# Jointex Fashion Wears Ltd. (Unit-3)

13<sup>th</sup> September 2017

# Observations

Floor Layout Plan

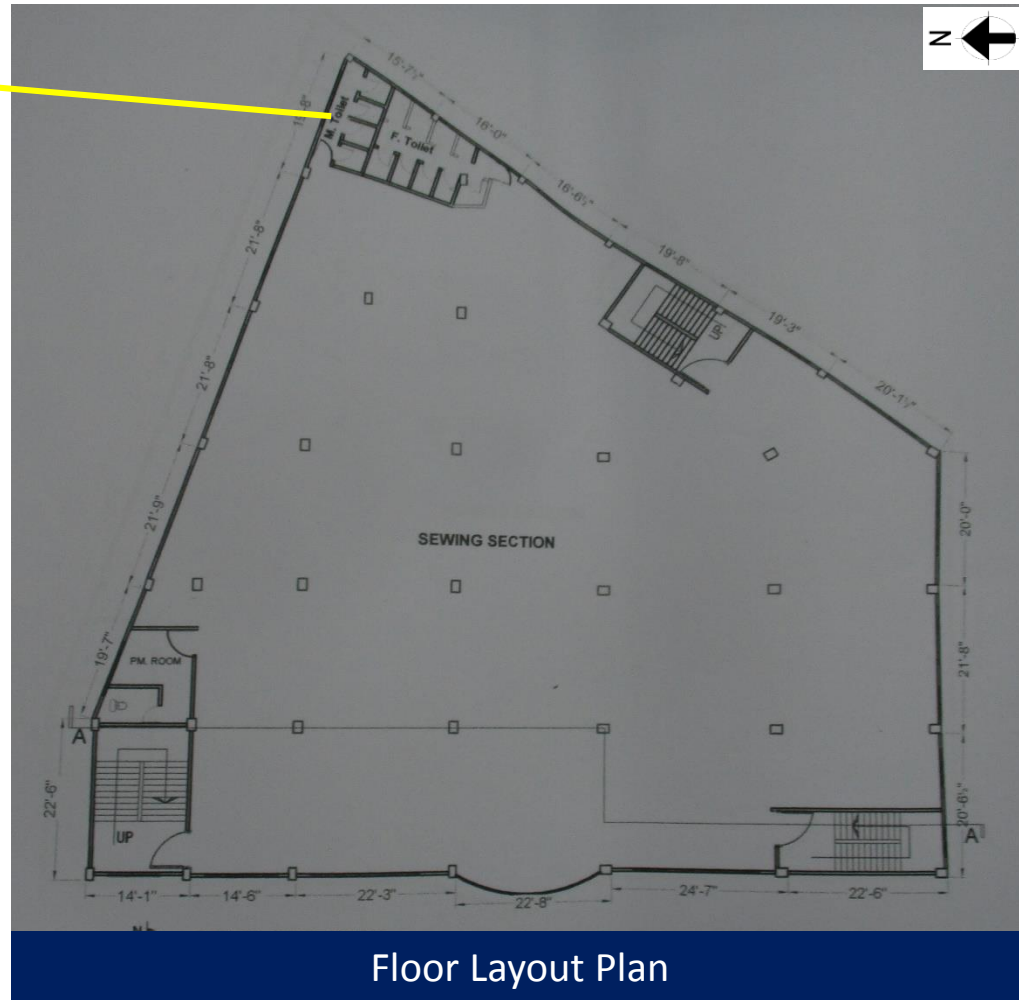
Toilet build up in several floor.  
Max 200 mm

Cursory calculation indicates that Columns appears to be stressed above normal design limits.

column layout.

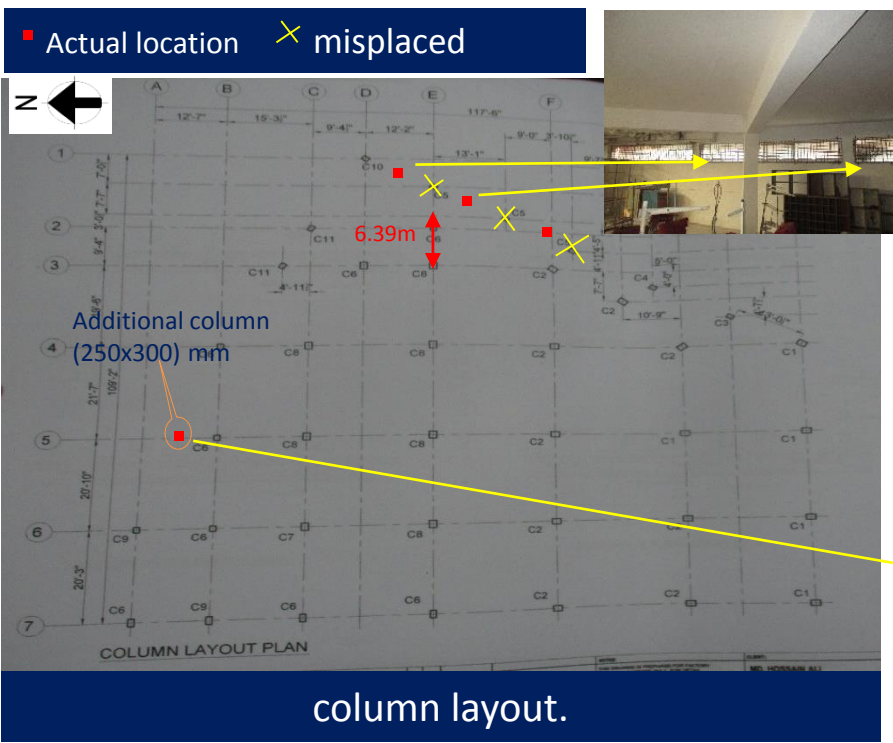
Column size and nos. of rebar & rebars dia are not fully match with column schedule. Building engineer is required confirm the dia, size & nos. of rebar on each column.

Grid dimension in between grid- 2 & 3 and position of columns at East didn't match with column layout. Also an additional column was found on grid 5. No foundation system is shown on drawings for the additional column. So the load path and foundation system of the column is required to investigate by factory engineer. Mismatches are shown in red on drawings.

Beam Layout

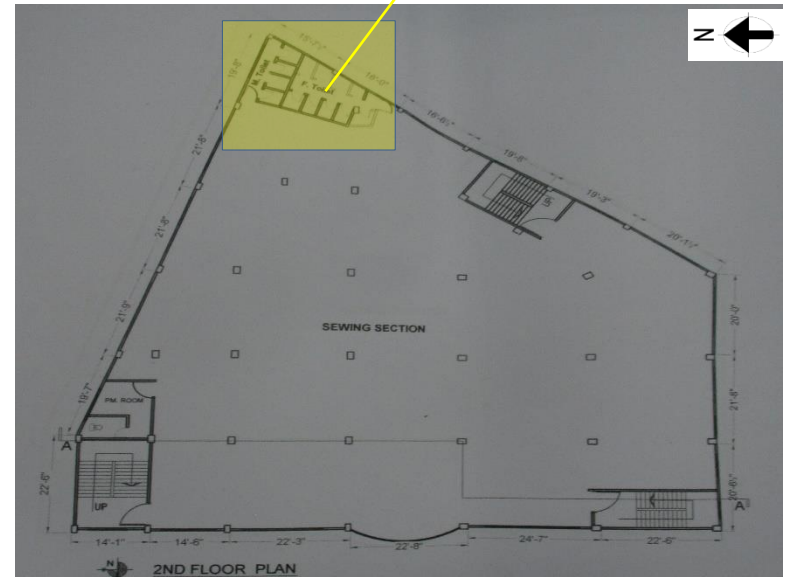
Architectural drawings were not updated as per site condition. Partition walls of toilet block at North-east corner did not match with layout plan.

Slab details were not provided in structural drawings. Beam layouts were not match in some floors. Mismatches are shown in red on layout.

Retrofitting column schedule

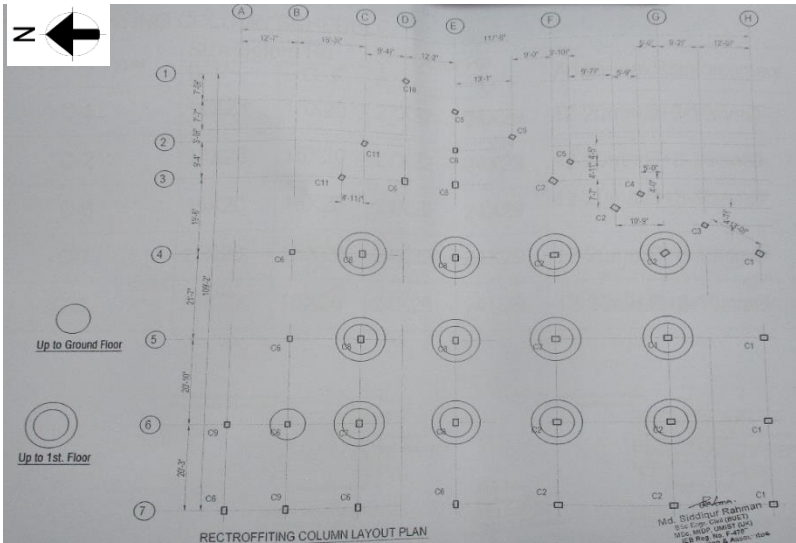
According to the provided DEA report, few columns and foundations are needed to be retrofitted. Factory has already carried out the remedial works. However few columns have found stressed above normal design limits. So DEA report is required to review by ACCORD.

No material strength specification were mentioned in retrofitting scheme. No material test report was available for retrofitting work.
